From: D'Almeida, Carolyn [/O=EXCHANGELABS/OU=EXCHANGE ADMINISTRATIVE GROUP (FYDIBOHF23SPDLT)/CN=RECIPIENTS/CN=9EC4401AFA1846DD93D52A0DDA973581-CDALMEID]
Sent: 5/13/2019 4:11:37 PM
To: Jennings, Eleanor [Eleanor.Jennings@parsons.com]; 'Wayne Miller' [Miller.Wayne@azdeq.gov]
CC: d p [DPope@css-dynamac.com]; Davis, Eva [Davis.Eva@epa.gov]; Nicole Goers [Nicole.Goers@TechLawInc.com]; 'Brasaemle, Karla' [KBrasaemle@TechLawInc.com]; 'Rohrbaugh, Amanda' [ARohrbaugh@TechLawInc.com]; 'Bo Stewart' [bo@praxis-enviro.com]; William Hughes [William.Hughes@cn-bus.com]; 'steve@uxopro.com' [steve@uxopro.com]; 'Panzino.Paula@azdeq.gov' [Panzino.Paula@azdeq.gov]
Subject: RE: ST012 Site Activities

From: Smallbeck, Donald R. <donald.smallbeck@woodplc.com>
Sent: Wednesday, May 8, 2019 1:47 PM
To: 'JERRARD, CATHERINE V CIV USAF HAF AFCEC/CIBW' <catherine.jerrard@us.af.mil>; 'Wayne Miller' <Miller.Wayne@azdeq.gov>; D'Almeida, Carolyn <dAlmeida.Carolyn@epa.gov>; Pearson, Stuart C. <stuart.pearson@woodplc.com>
Cc: d p <DPope@css-dynamac.com>; Davis, Eva <Davis.Eva@epa.gov>; GANGNUSS, GREGORY G GS-14 USAF HAF AFCEC/CIBP <gregory.gangnuss@us.af.mil>; Nicole Goers <Nicole.Goers@TechLawInc.com>; 'Brasaemle, Ka

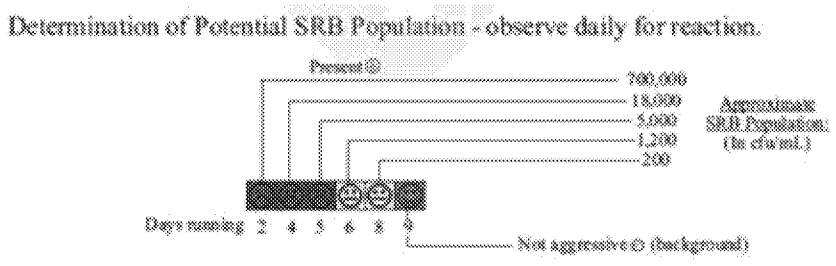
With the use of smiles and frowns as population indicators, I see what you mean about not being quantitative. But in our case, shouldn't the smiles and frowns be reversed?
